Westinghouse Electric Company
Nuclear Power Plants
P.O. Box 355
Pittsburgh, Pennsylvania 15230-0355
USA

Subject: AP1000 Response to Requests for Additional Information (SRP3.9.2)

Response to Requests for Additional Information on SRP Section 3.9.2

AP1000 TECHNICAL REPORT REVIEW

Figure 1

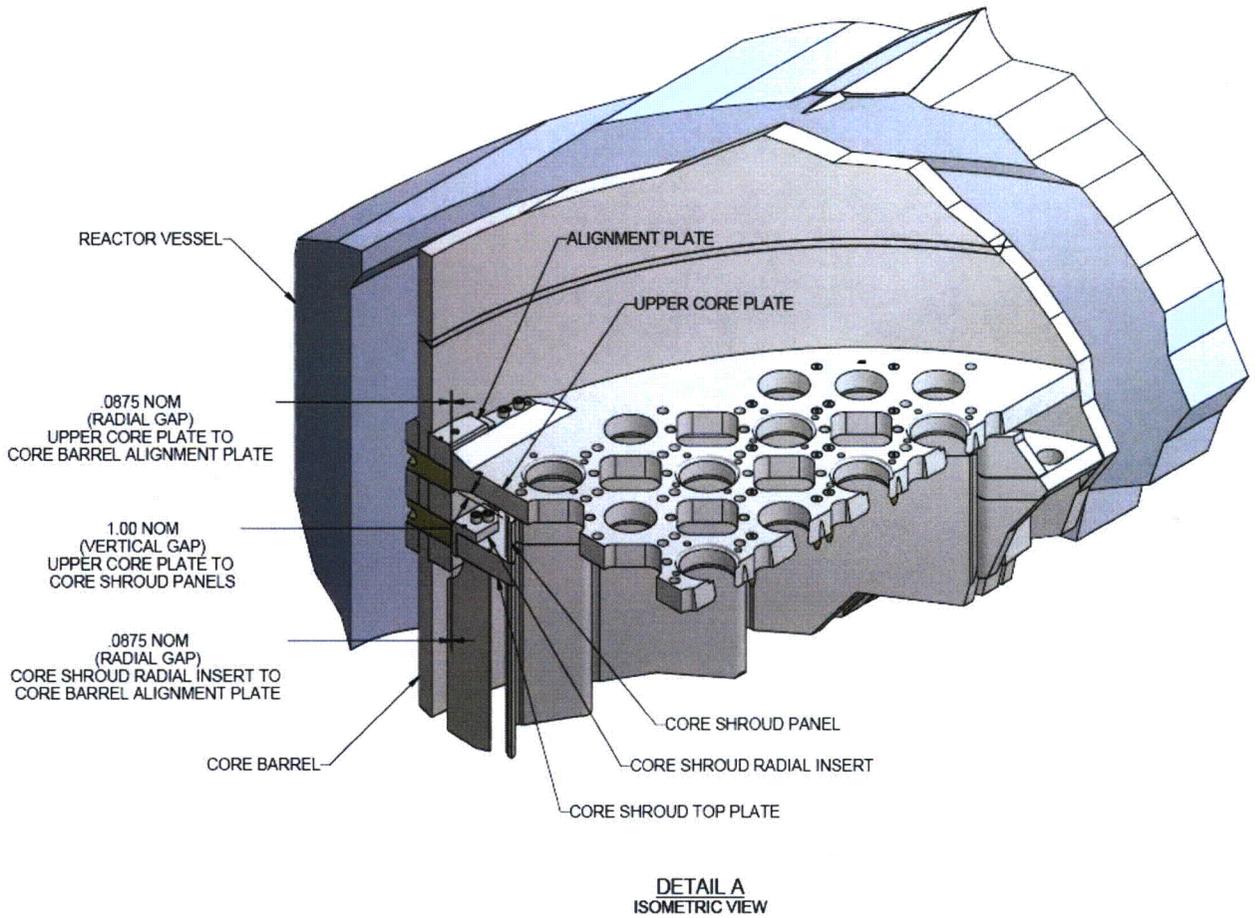
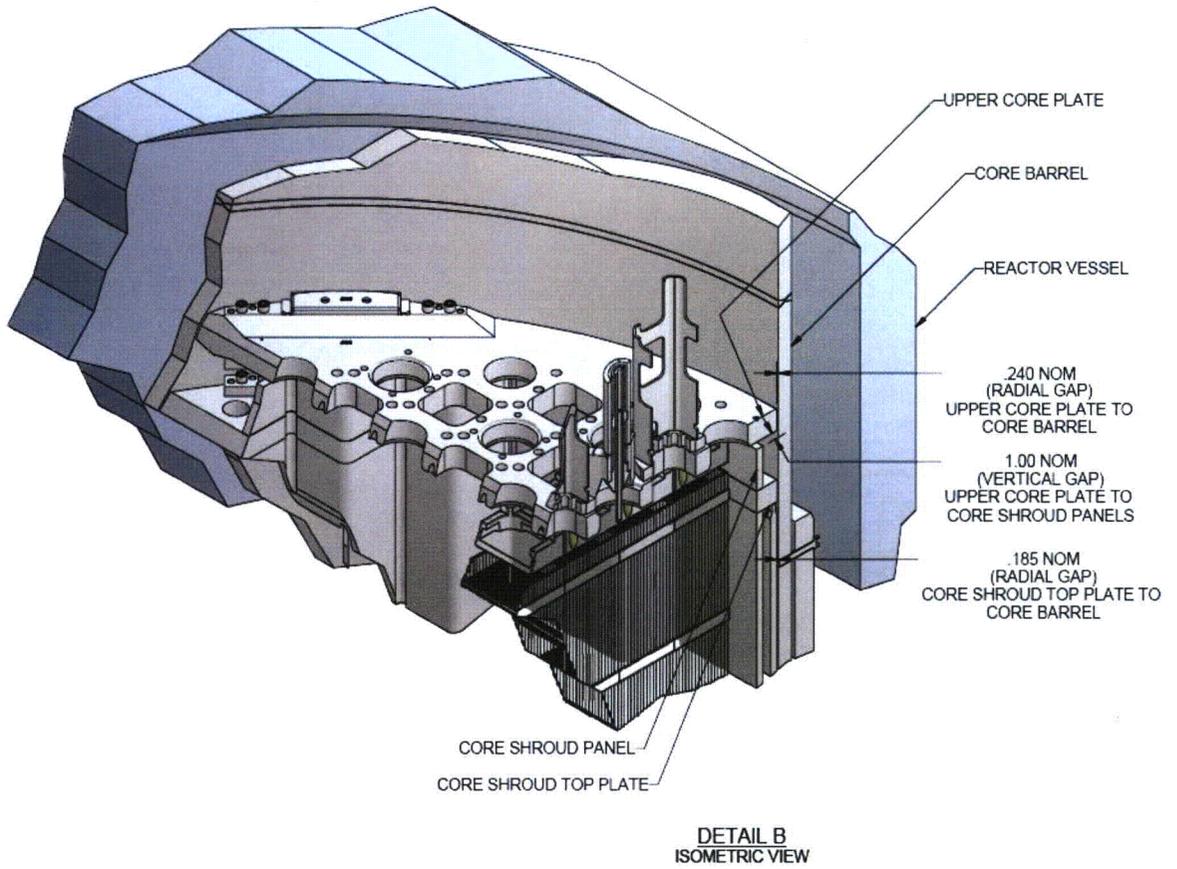
Describe the design and modeling of the core barrel/upper core plate as they relate to flow-induced vibration (FIV) structural dynamic analysis. What is the uncertainty that the model of the interface employed in the modal analysis is representative of the physical support?

The upper core plate is modeled as a part of the upper internals in the system model. The gaps between the upper core plate (and core shroud) slots and the alignment plates mounted on the core barrel are also modeled (see Figures 1 and 2).

To ensure that the entire range of possible gaps between the upper core plate and the core barrel alignment plates is evaluated, time-history analyses were performed with various sets of gaps (upper core plate, top core shroud plate, and core barrel lower supports). Table 6-9 in WCAP-15949-P, Rev 2 (Reference 1), shows the gaps modeled and the resulting loads. The resulting highest load was used in the structural analysis.
